Subject: Revised Human Health Risk Assessment Work Plan for Santa Susana Field Laboratory Order Pursuant to California Water Code 13383; CA0001309 CI No. 6027
Attachments: WaterboardComments13383_2016 21o.pdf

Subject: Revised Human Health Risk Assessment Work Plan for
Santa Susana Field Laboratory, Ventura County, CA
(Order Pursuant to California Water Code 13383; CA0001309 CI No. 6027)
http://www.waterboards.ca.gov/losangeles/public_notices/Boeing/Boeing%20SSFP/020Revised%20HHRP/020Workplan_3_31_16.pdf

Total Seasonal Rainfall (Precipitation) Los Angeles Civic Center, 1877-2015

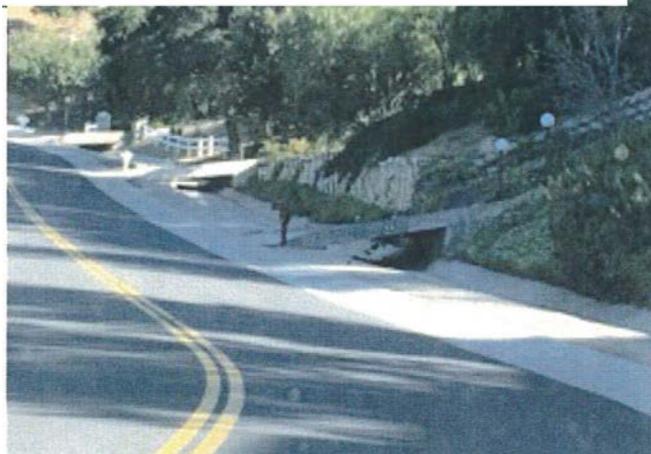
9. Documented in the NPDES permit 00001309 historical precipitation data. It cannot be stated that these are years most indicative of future conditions since we have had El Nino conditions this year, and high rain years which will have vastly different migration pathways based on groundwater elevation, saturation of bank storage, as well as groundwater pump testing.

10. It is recommended that data include the years 2002 thru 2015 which indicate the conditions of the site when these agreements were signed and promised, as well as providing representative years of both high and low precipitation. Additionally, grading will likely be massive and complicated, and data resources that explicitly include operational discharge

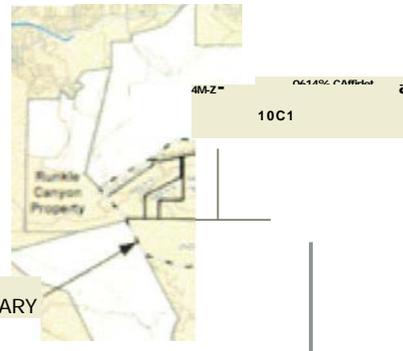
Please update maps and figures to reflect **accurate neighboring ownership**

- BBI should be listed as American Jewish University
- Bell Canyon [directly adjacent] is not identified
- Centex should say Dayton Canyon

PCBs in Soil

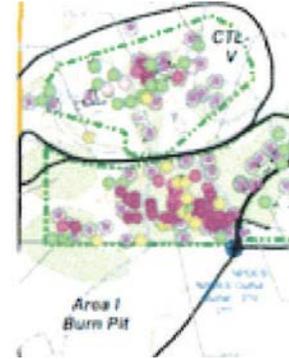
- Ex1F•nsive CMS areas, bug ConcernPd that downer-ad
lent areas are not adequatt•ly sampled.

Metals in Soil

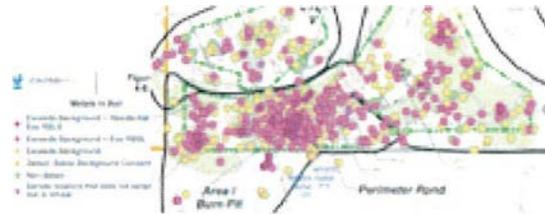
- Same comment about adequate \$am pimp. to
the south for these constshuents of concern.

Dioxins in Soil

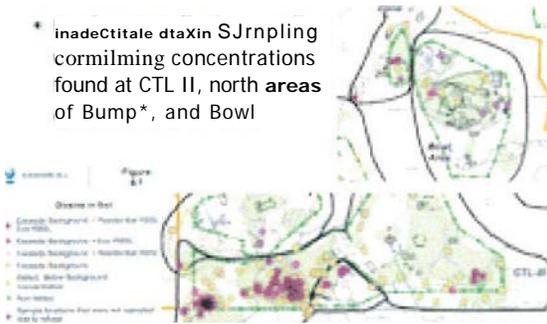
- * inadctitale dtaXin SJrnplng
cormilming concentrations
found at CTL II, north areas
of Bump*, and Bowl

Burial of Barrels

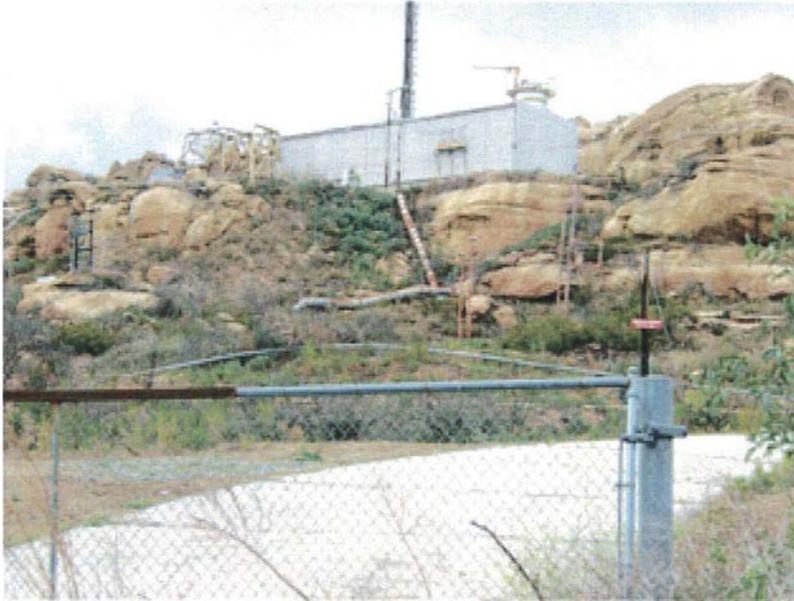
- Is this from the Area 1 Burnpit? If not, which location is it from?

Area 1 Burnpit drainage perspective

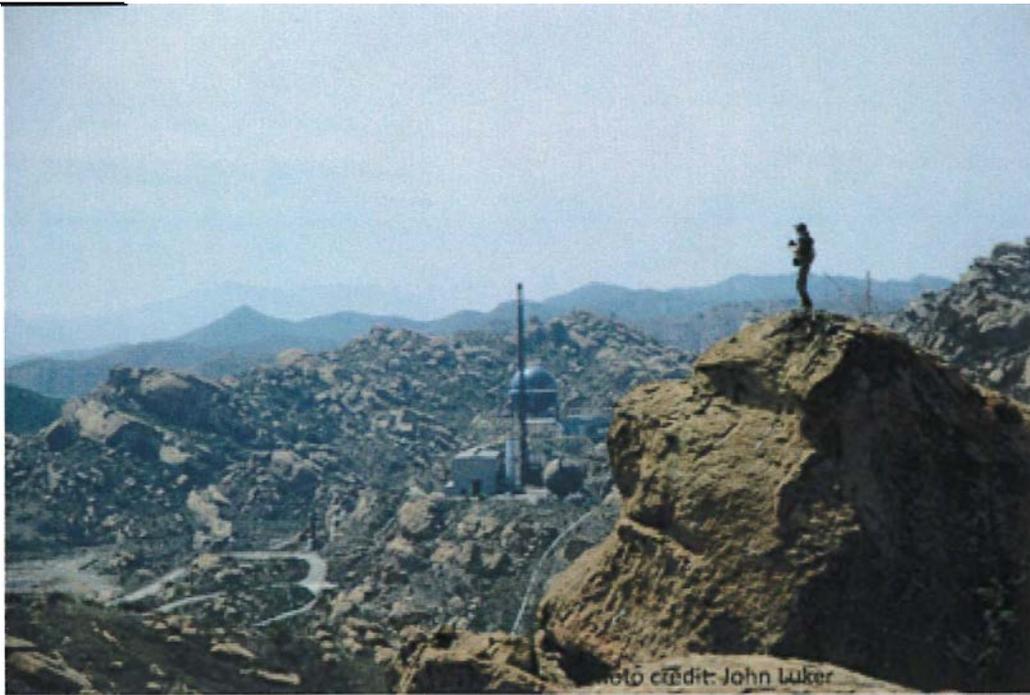
CTL HI reclamation pond not shown
